B L E G G E N R E M O D E L

ATTIC REMODEL
1/4" = 1'-0" CLG HGT. = EXIST.

PROJECT NAME
ATTIC REMODEL

SHEET NAME
FLOOR PLAN
SHEET #

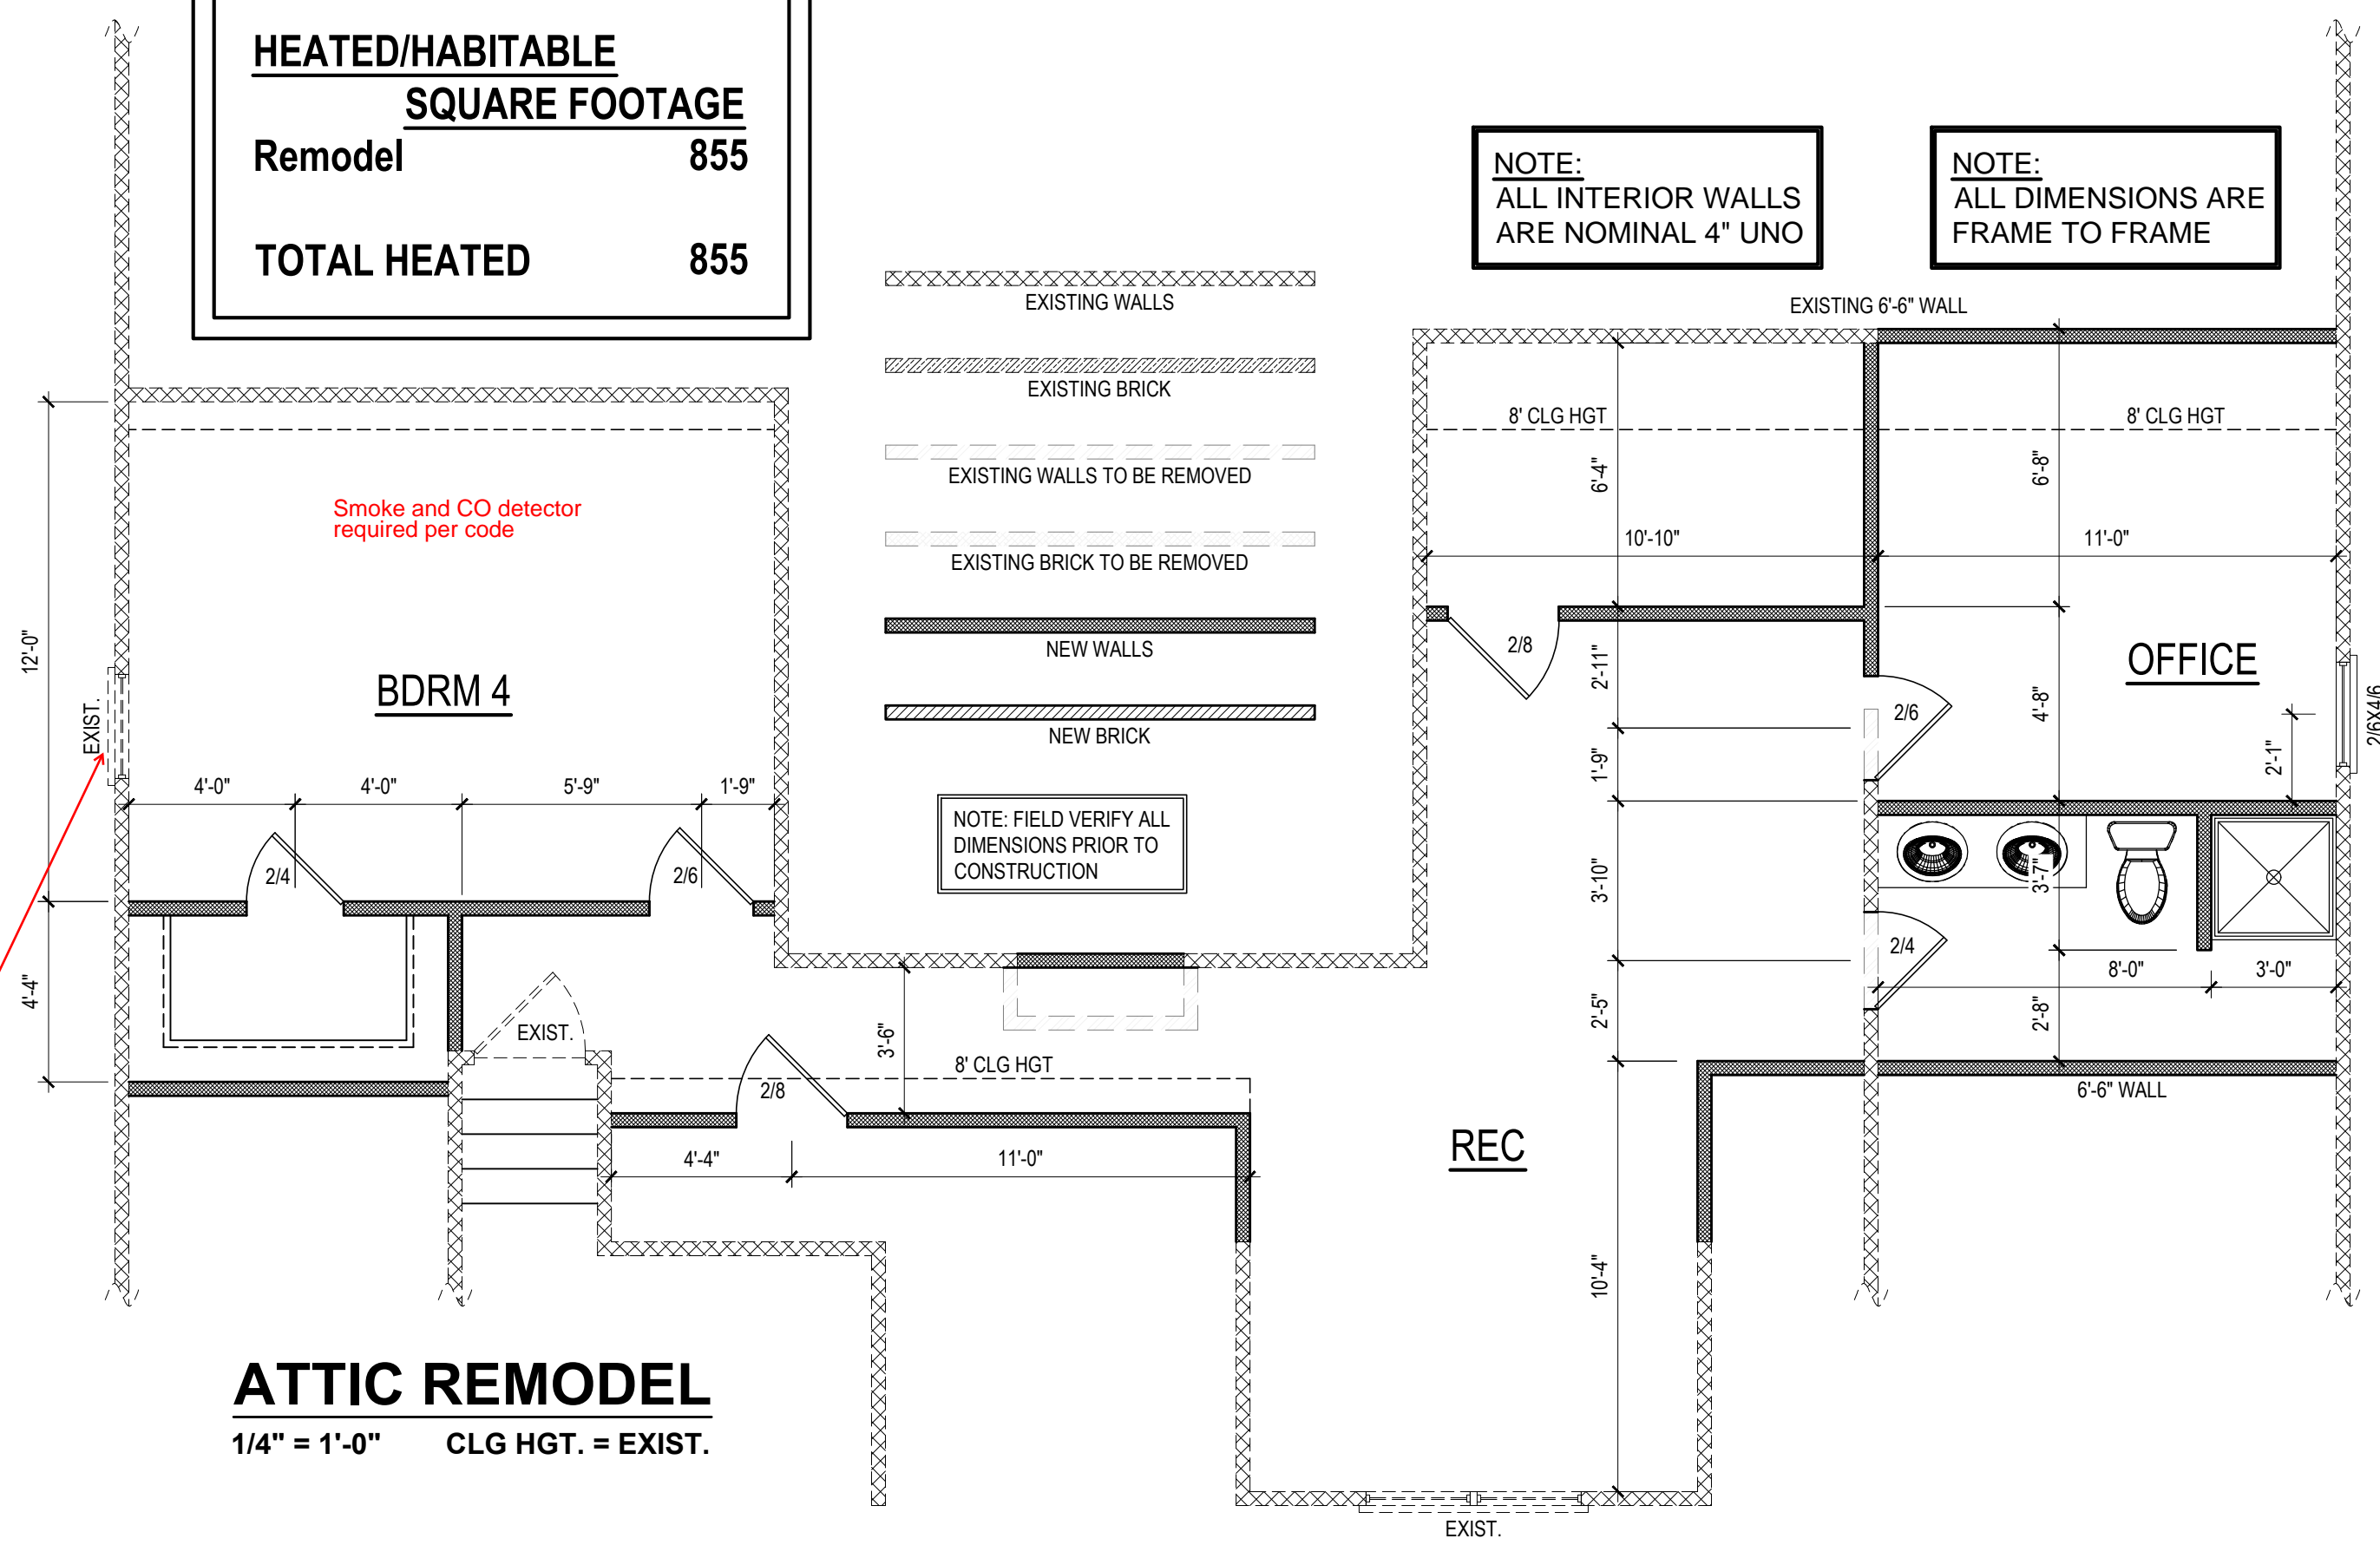
This window must meet egress requirements
